Add the following text: "PCD File No. PPR-21-015".

DRAWN BY: D.E. WATTS DATE: 12-10-20 DWG. NO.: 20-5564-01 SURVEYED BY: DEW, ESV, 12-10-20	APPROVED BY: PROJ. NO.: DWG.:	REVISIONS:	OLIVER E. WATTS CONSULTING ENGINEER COLORADO SPRINGS	PROJECT: 16810 SOUTH PEYTON HIGHWAY PART NE S8, T.17S., R.63W., 6TH P.M. EL PASO COUNTY, COLORADO	SHIT. NAME: SITE PLAN	SHIT. NO.: 1 OF 1
---	-------------------------------------	------------	--	--	---------------------------------	----------------------------

Site Development Plan_V1.pdf Markup Summary

Scale 1" = 100'

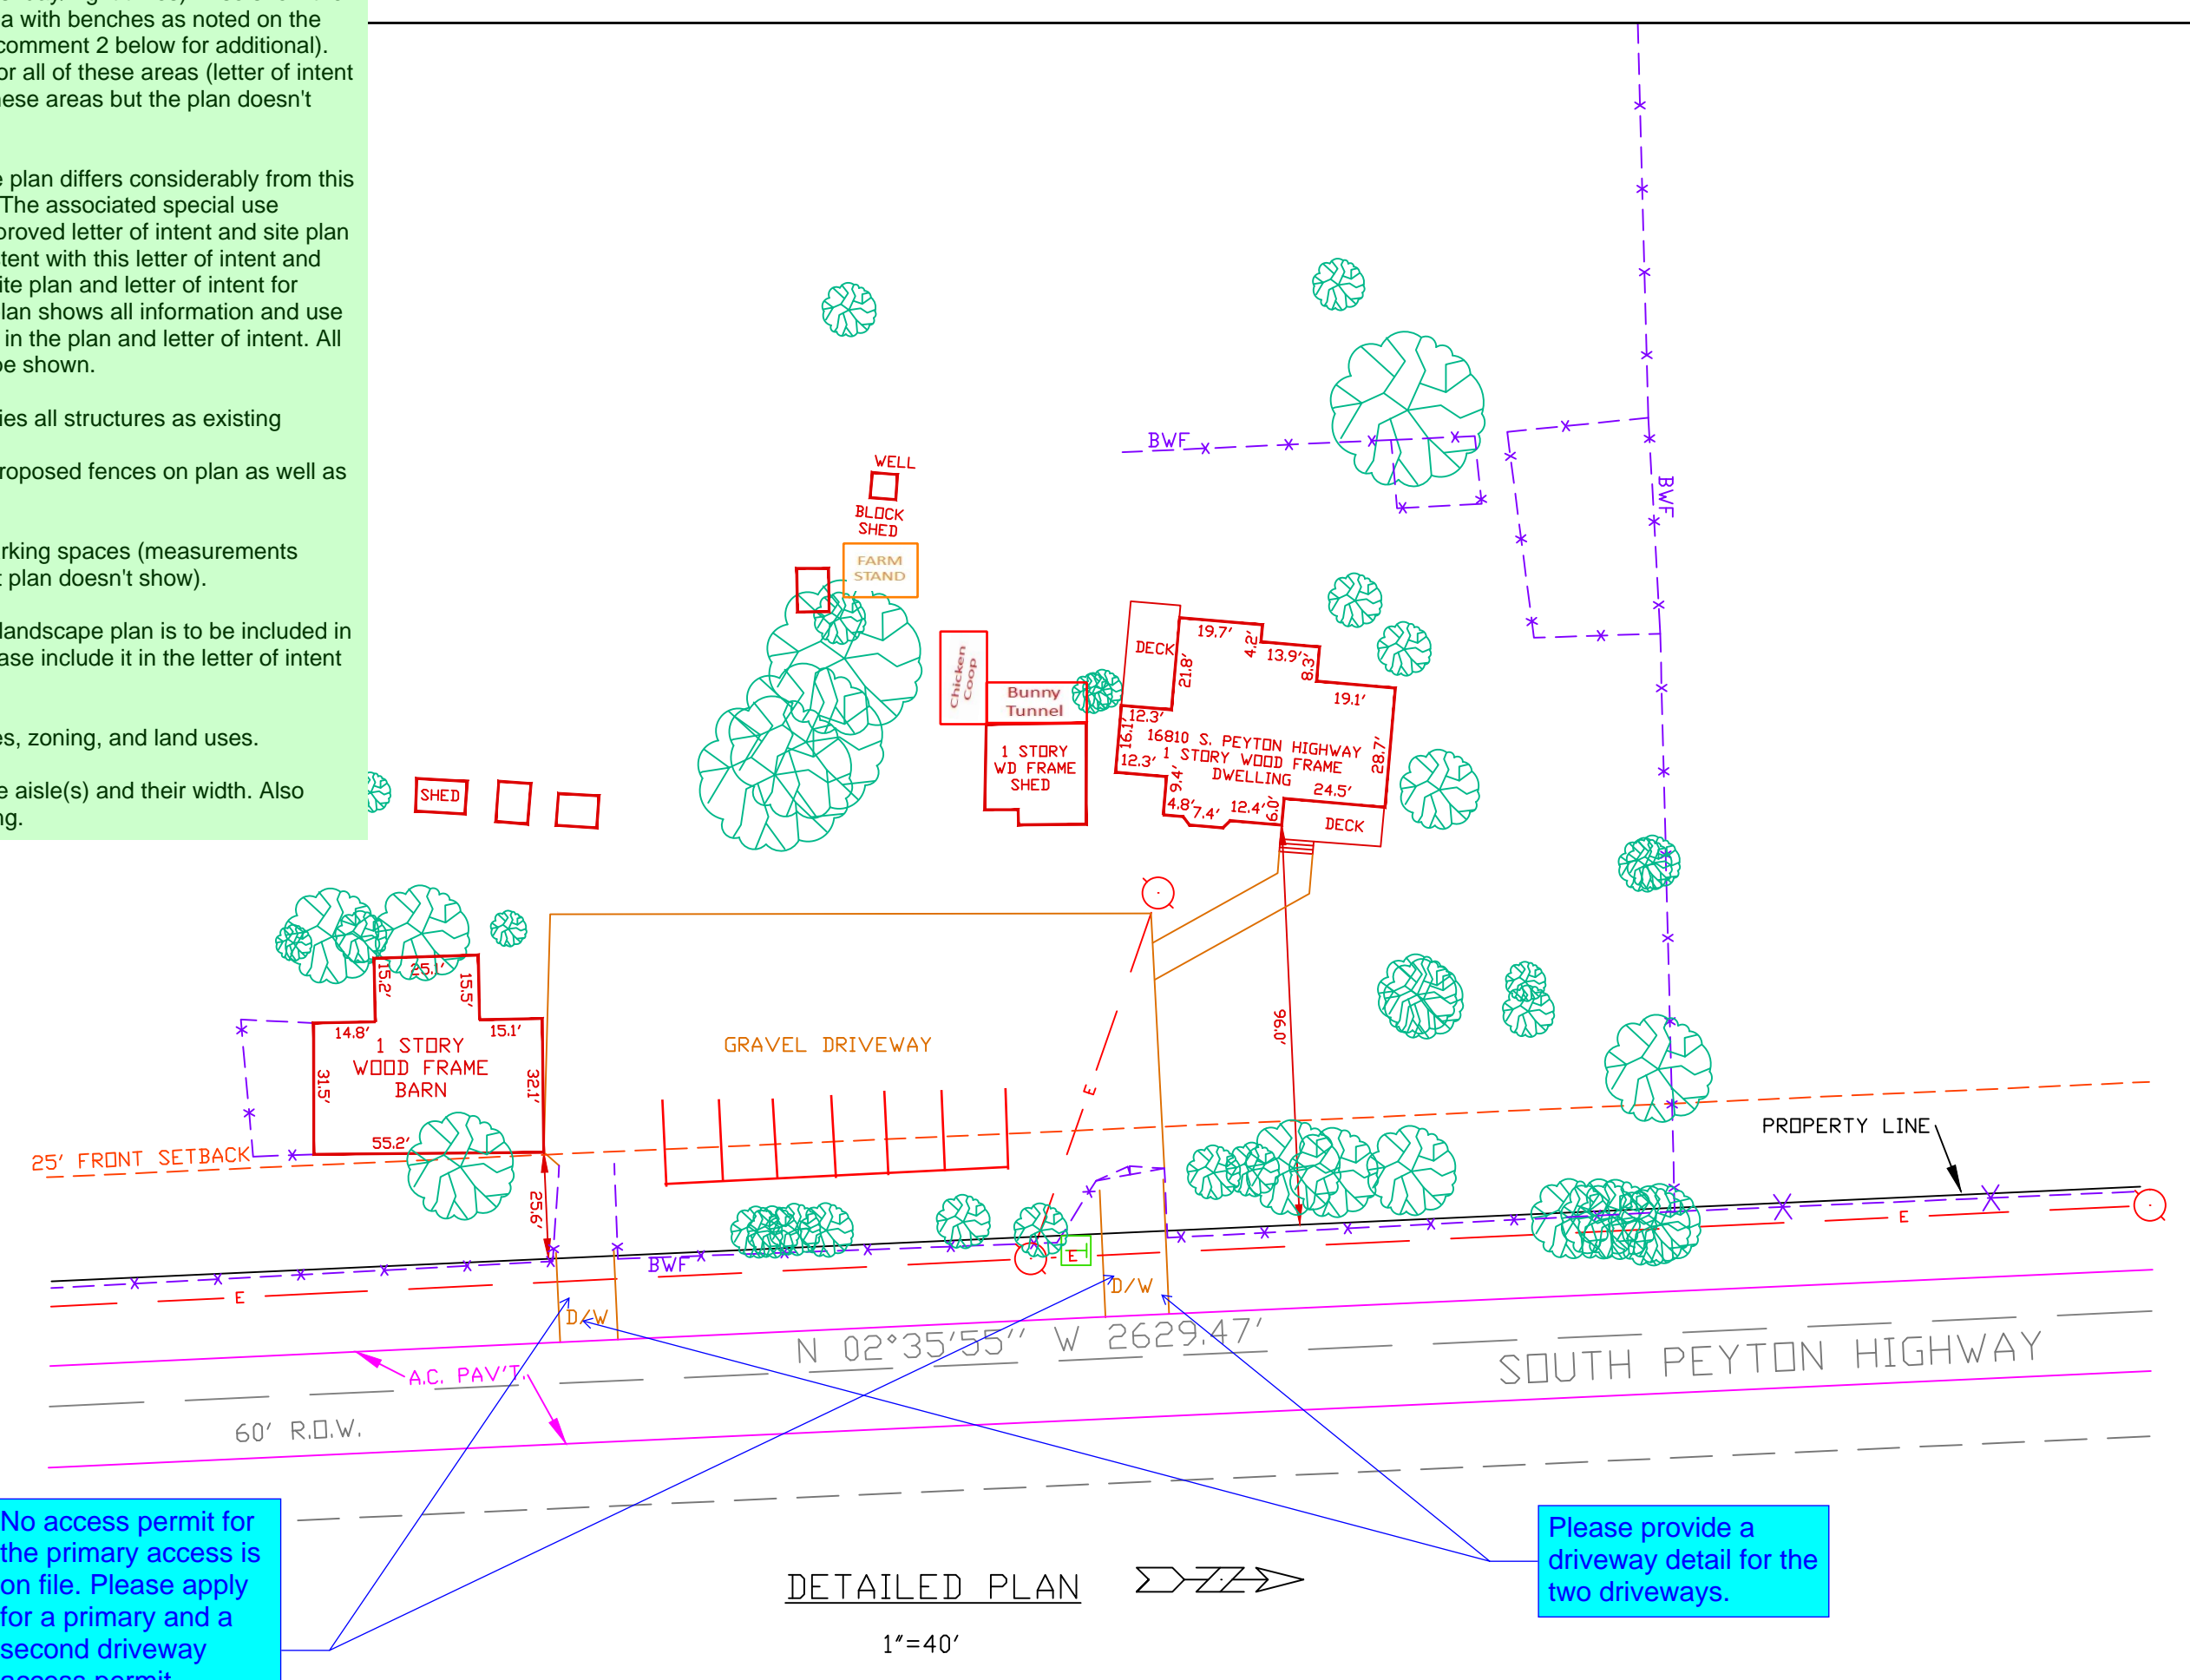
1. Please show the proposed petting zoo enclosure location, as well as indicate the area(s) where the animals are/will be kept at various times (during events vs. day/night times). Also show the proposed teaching / picnic area with benches as noted on the special use site plan (refer to comment 2 below for additional). Please show measurements for all of these areas (letter of intent describes measurements of these areas but the plan doesn't show them).

2. The associated AL1928 site plan differs considerably from this one in terms of level of detail. The associated special use approval identifies that the approved letter of intent and site plan for that project must be consistent with this letter of intent and site plan. Please refer to the site plan and letter of intent for AL1928 and ensure that this plan shows all information and use components shown/described in the plan and letter of intent. All use components will need to be shown.

3. Please add note that identifies all structures as existing

4. Please show existing and proposed fences on plan as well as on the legend.

5. Show measurements for parking spaces (measurements described in letter of intent but plan doesn't show).

6. If pumpkin patch shown on landscape plan is to be included in the agritainment use, then please include it in the letter of intent and site plan.

7. Show adjacent property lines, zoning, and land uses.

8. Identify entry drive and drive aisle(s) and their width. Also show existing gate near parking.

DETAILED PLAN
1"=40'

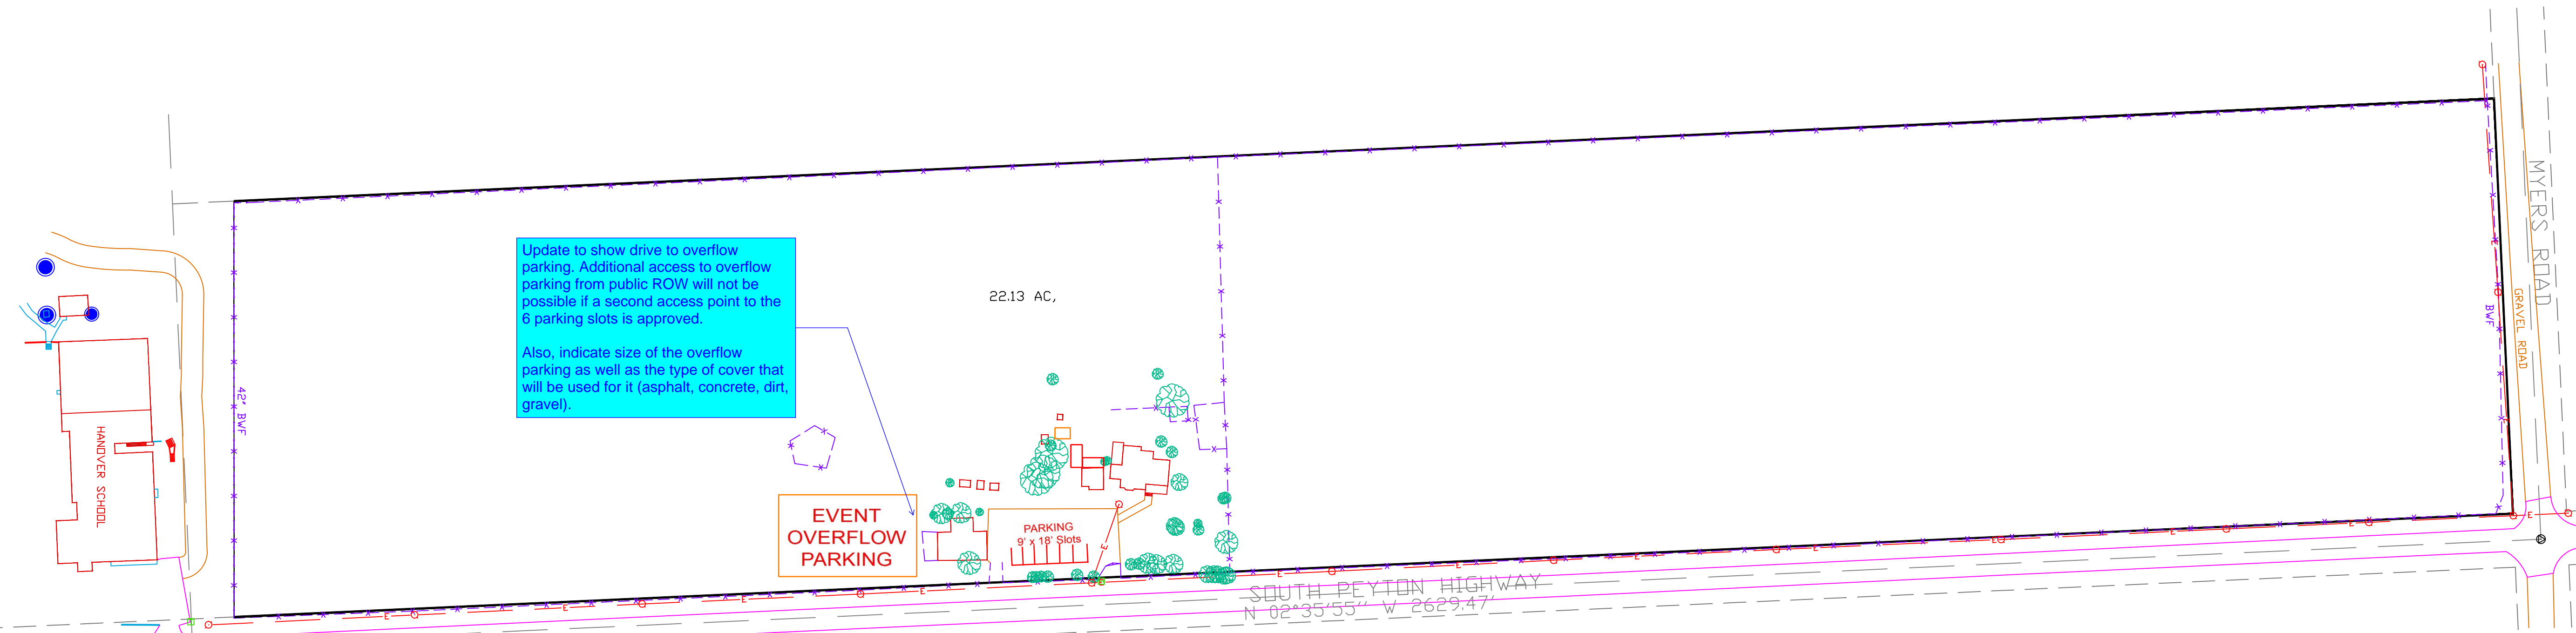
No access permit for the primary access is on file. Please apply for a primary and a second driveway access permit through EDARP under initiate minor application.

Please provide a driveway detail for the two driveways.

Update to show drive to overflow parking. Additional access to overflow parking from public ROW will not be possible if a second access point to the 6 parking slots is approved. Also, indicate size of the overflow parking as well as the type of cover that will be used for it (asphalt, concrete, dirt, gravel).
